PLANNED UNIT DEVELOPMENT

& SUBDIVISION STAFF REPORT Date: August 20, 2009

DEVELOPMENT NAME Noble Drive East Subdivision, Resubdivision of Lots 1 & 2

CONTEMPLATED USE Planned Unit Development Approval to allow multiple

SITE PLAN

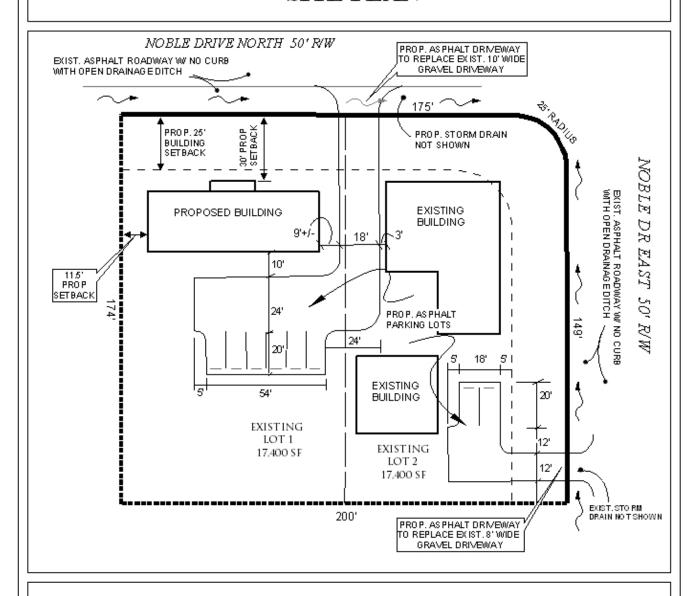
The site plan depicts the existing and proposed development. All of the structures, as proposed, will meet setback requirements except the existing easternmost building which will be partially within the front yard setback. As this is an existing condition, the structure would be considered legally non-conforming.

The Zoning Ordinance requires parking to be provided at a ratio of 1.5 parking spaces per dwelling unit. Accordingly, four dwelling units require six parking spaces. The site depicts eight asphalt parking spaces of adequate size to meet these requirements. The site plan further depicts two curb cuts. The curb cut to Nobile Drive North and the driveway to the parking area are depicted with widths of 18 feet. The curb cut to Noble Drive East and the driveway to the second parking area are depicted with width of 12 feet. The zoning ordinance requires driveway widths of 24 feet for two-way accessways to ensure enough room for passing vehicles. The site plan should be revised to depict accessways of 24 feet.

No dumpster is depicted on the site plan. If a dumpster is proposed it should be depicted on the site plan and meet all enclosure, buffer, access and maneuvering, and setback requirements; or a

note on the site plan should be provided indicating that no dumpster will be included as part of the development and waste removal will occur by curbside pickup.

Compliance with the tree planting and landscaping ordinances is not depicted on the submitted site plan. Full compliance with these regulations will be required as the site is zoned B-3.

No sidewalks are depicted on the site plan. Sidewalks should be depicted, or a sidewalk waiver should be submitted and approved.

- 1) Completion of the Subdivision process;
- 2) Revision of all curb cuts and accessways to a minimum width of 24 feet;
- 3) Provision of a buffer compliant with Section 64-4.D.1 of the Zoning Ordinance along the South and West property lines;
- 4) Depiction of a dumpster on the site plan showing compliance with all enclosure, buffer, access and maneuvering, and setback requirements or a note on the site plan be provided indicating that no dumpster will be included as part of the development and waste removal will occur by curbside pickup;

- 5) Full compliance with all landscaping and tree planting ordinances;
- 6) Depiction of sidewalks or submittal of a successful sidewalk waiver application;
- 7) Compliance with Engineering Comments: Must comply with all storm water and flood control ordinances. Detention must be provided for any increase in impervious area added to the site excess of 4000 square feet. The location of the detention area(s) shall be shown on the final plat. Any work performed in the right of way will require a right of way permit;
- 8) Revision of the site plan to show compliance with all conditions and submittal of two copies of said revised site plan to the Planning Section of Urban Development prior to the issuance of any permits; and
- 9) Full compliance with all municipal codes and ordinances.
